UNITED STATES PATENT AND TRADEMARK OFFICE

APPLICATION NO.	FILING DATE	FIRST NAMED INVENTOR	ATTORNEY DOCKET NO.	CONFIRMATION NO.
10/527,524	10/15/2005	Kendall Munday	DAVI254.001APC	3219
29995 7590 05/12/2009 KNOBBE MARTENS OLSON & BEAR LLP 2040 MAIN STREET FOURTEENTH FLOOR IRVINE, CA 92614				
EXAMINER BRADFORD, CANDACE L				
ART UNIT 3634		PAPER NUMBER		
NOTIFICATION DATE 05/12/2009		DELIVERY MODE ELECTRONIC

Office Action Summary

DETAILED ACTION

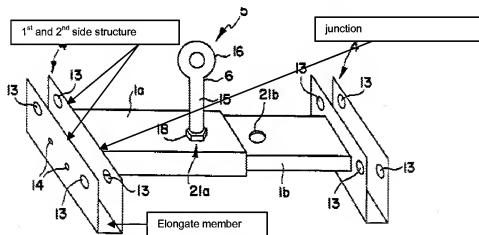
Claims 1-6, 8, 10, 13-20, 23-27, and 29-32 rejected under 35 U.S.C. 102(b) as being anticipated by Arisman et. al. (5346036). Arisman et. al. discloses an attachment member 4, adapted to removably attach to an exterior edge region of a roof surface 8, a force distribution member 1a,15, extending transversely to the attachment member and adapted for location on an upper surface of the roof, a connector 5, mounted to the attachment member of the force distribution member, the connector adapted to receive a load support line, wherein the connector is positioned in the vicinity of a junction between the attachment member and the force distribution member and also being in the vicinity of the exterior edge region of the roof surface, wherein the connector is positioned in a lower half and quarter of the force distribution member, as best seen in Figure 1, when the connector 5, is inserted into and through the force distribution

member 1a, and position and secured by a nut 17, as best seen in Figure 6 and 10, and positioned within 10cm, 20cm and 50 cm of the junction, wherein the attachment member is formed as an elongate member having a gap formed by a first side structure and a second side structure spaced from the first side structure, the gap adapted to locate around an edge of the roof, as best seen in the attached Figure 2, wherein the first side structure is contoured to conform to a profile of an underside of the roof edge as best seen in Figure 8, wherein the first side structure and second side structure form clamping means for clamping at least a part of the rood edge in the gap, wherein the clamping means is adjustable to vary the gap, wherein the attachment member includes a stop structure to engage an edge of the roof, as best seen in the attached Figure 2, wherein the stop structure is a wall, wherein the second side structure is formed as two shaft members each with a longitudinal axis oriented substantially perpendicular to the first side structure, wherein the two shaft member are positioned each towards a respective outer end of the elongate members, wherein the shaft members are threadably engaged with support brackets thereby providing adjustment means for adjusting the gap, wherein the force distribution member is substantially perpendicular to the attachment member, wherein the force distribution member is formed as a substantially planar member, wherein the force distribution member includes a foot 4, engaging the roof surface, an attachment foot formed as an elongate L shaped bar, two spaced locking arrangement disposed transversely to one surface of the L shaped bar and positioned to each co-operate with a respective end region of the attachment foot, a cylindrical arm connected approximately centrally to the foot and extending

perpendicular thereto, an attachment aperture formed in or mounted on the foot or the arm, wherein the components are configured to compressively engage a roof edge region between one surface of the L shape bar and the locking arrangement, with the arm positionable on the roof and that attachment aperture, in use positioned in the vicinity of the roof edge, wherein the spaced locking arrangements are each a threaded shaft mounted in a threaded bracket and rotatable into and out of contact with the roof to thereby fix the anchor in positioned, placing an attachment member in contact with an edge of the roof, positioning an arm directed upward on the roof, the arm extending transversely from the attachment member, fixing a safety ling to the roof at or around the level of the roof edge, as best seen in attached Figures 1, 2, and 6.
